**MONTGOMERY COUNTY HISTORIC PRESERVATION COMMISSION**  
**STAFF REPORT**

<b>Address:</b>	6403 Connecticut Ave., Chevy Chase	<b>Meeting Date:</b>	3/23/2022
<b>Resource:</b>	Contributing Resource Chevy Chase Village Historic District	<b>Report Date:</b>	3/16/2022
<b>Applicant:</b>	Jessica Killin	<b>Public Notice:</b>	3/9/2022
<b>Review:</b>	Historic Area Work Permit	<b>Tax Credit:</b>	n/a
<b>Case Number:</b>	983046	<b>Staff:</b>	Dan Bruechert
<b>Proposal:</b>	Hardscape Alteration and Pergola Construction

**TITLE:** EX. & PROP. SITE PLANS  
**DATE:** 6-3-21, 7-26-21, 10-3-21, 10-18-21, 11-11-21,  
11-20-21, 1-20-22, 1-28-22

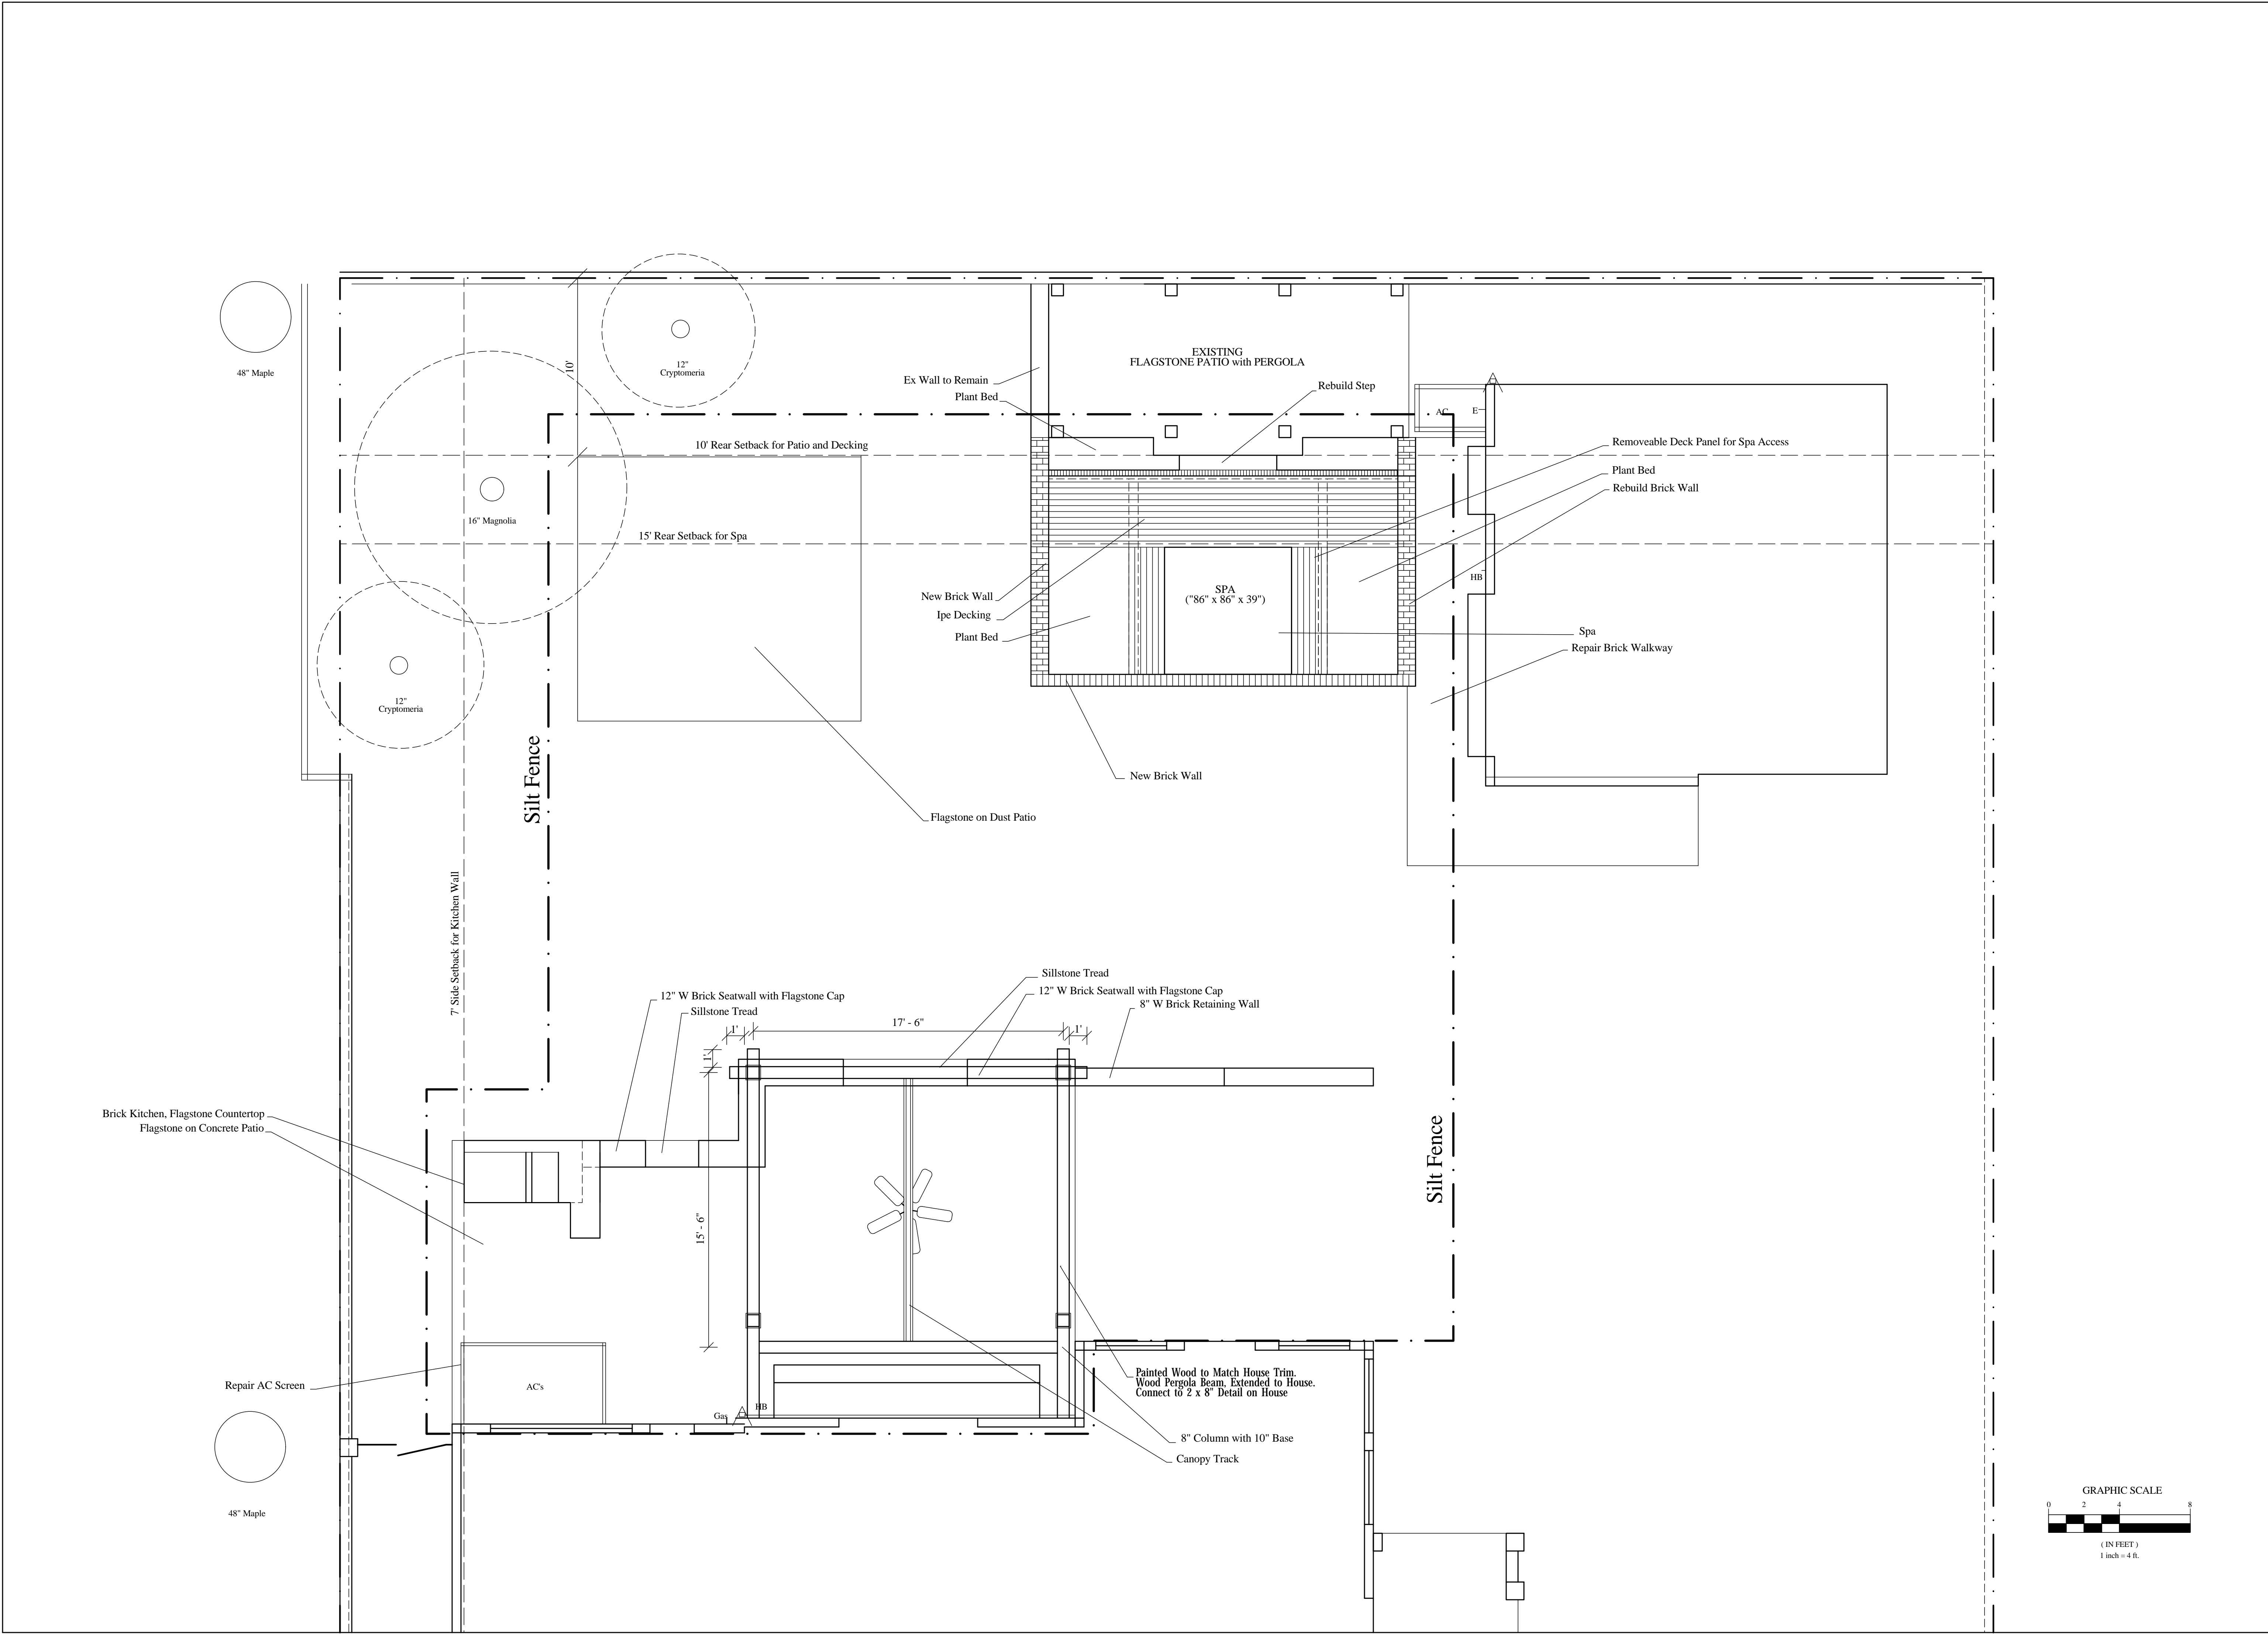
To the rear of the house, there is a brick patio with a small retaining wall. The patio extends the full width of the house and is approximately 9' (nine feet) deep. This patio is not historic and its removal will not impact the historic character of the site.

In place of the existing patio, the applicant proposes constructing a flagstone on a concrete patio with a brick retaining wall and installing a new wood pergola with a canvas roof measuring 15' 5" × 17' 5" (fifteen feet, five inches by seventeen feet, five inches).

This is an expansion of the existing hardscaping, so consideration needs to be given to both the lot coverage and the appropriateness of the pergola. Staff finds that the new patio will not impact the park-like character of the district because it is adjacent to the house and will not be visible from the public right-of-way and does not impact any trees. As a garden structure that is not visible from the public right-of-way, the proposed pergola is subject to lenient scrutiny. Staff finds that the size, mass, and materials are all appropriate for the proposed pergola and it will not impact the character of the surrounding district. Staff recommends the HPC approve the new patio and pergola under the *Design Guidelines*, 24A-8(b)(2) and (d), and Standards 2, 9, and 10.

In the northeast corner of the lot, the applicants propose to install a flagstone patio, 249 ft<sup>2</sup> (two hundred thirty-nine square feet) set on a dust base. The patio will be on grade and will not impact any of the existing trees in the corner of the lot.

Staff finds that because the proposed patio will not be visible from the public right-of-way and will not impact any trees, it should be reviewed under lenient scrutiny. Under this level of review, Staff finds that the size, material, and placement of the proposed patio are all appropriate. Staff recommends the HPC approve the proposed patio under the *Design Guidelines*, Chapter 24A-8(b)(2) and (d), and Standards 2, 9, and 10.

SECTION 1 SECTION - Spa Walls, Walkways

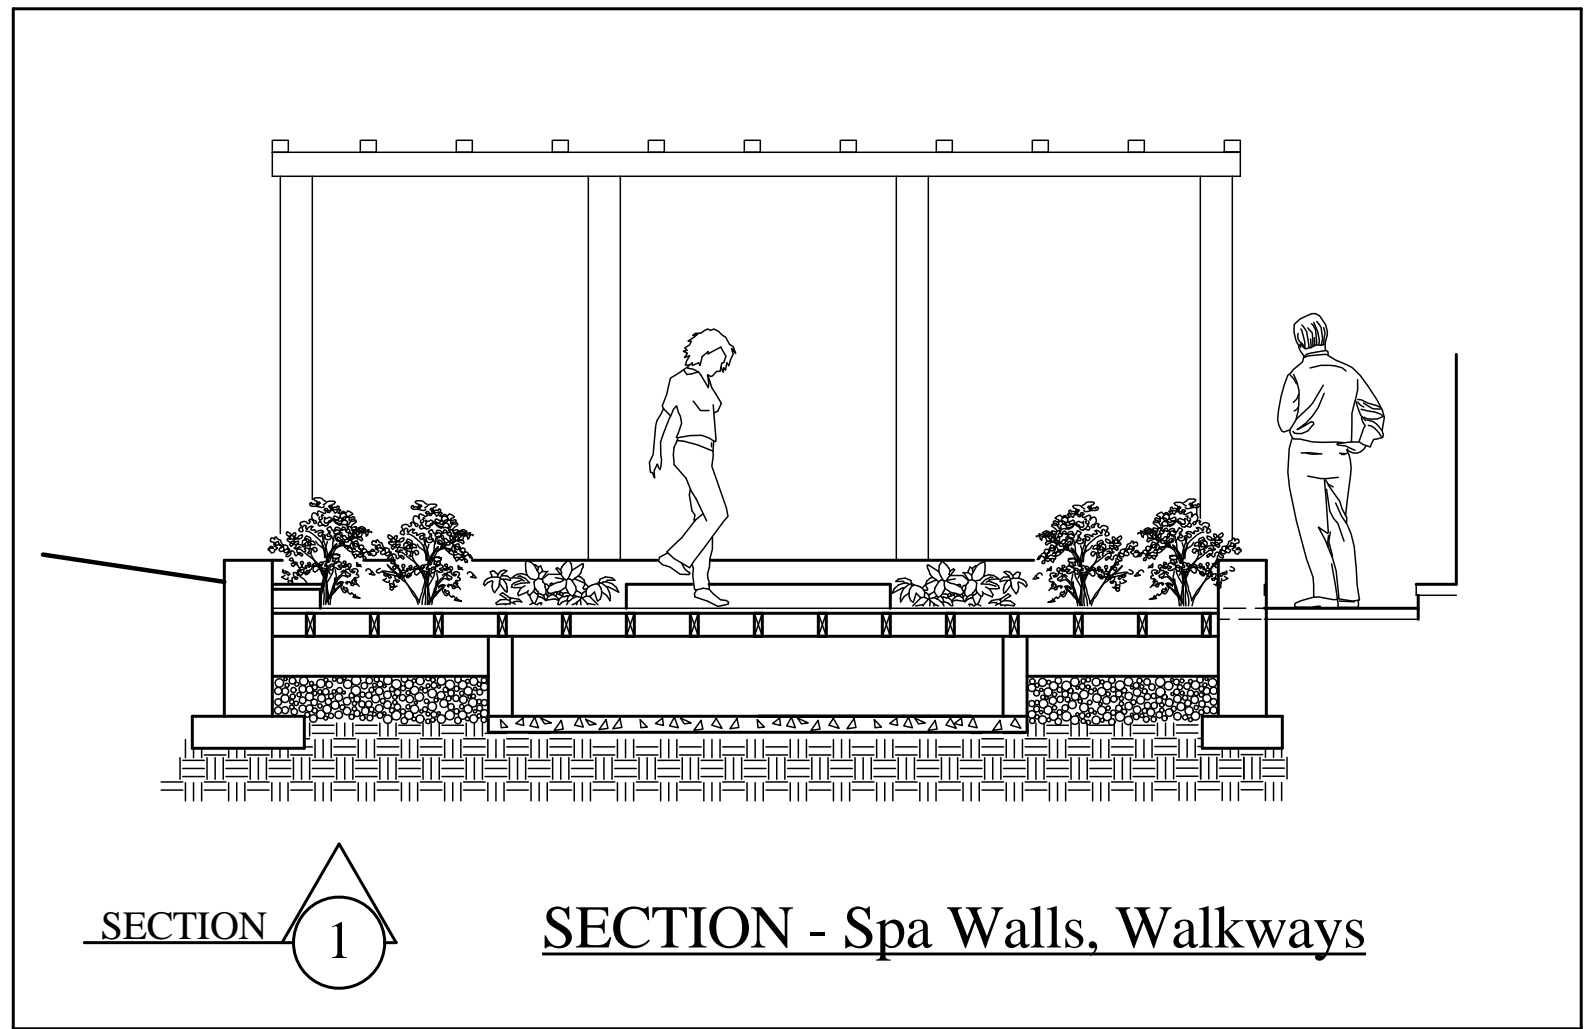
Adjacent to the ADU, the applicant proposes to install a new spa/hot tub surrounded by wood decking with a low brick wall surrounding it. Planters will flank the spa to the left and right. As with the other work proposed in this HAWP, the spa will not be visible from the public right-of-way and will not impact any trees.

Staff finds under the *Design Guidelines* the proposed spa is most analogous to a swimming pool and should be reviewed under lenient scrutiny. Under this level of review, Staff finds that the proposed spa will not impact the surrounding streetscape and the size and mass will not overwhelm the house or adjacent ADU. Staff recommends the HPC approve the HAWP under the *Design Guidelines*, Chapter 24A-8(b)(2) and (d), and Standards 2, 9, and 10.
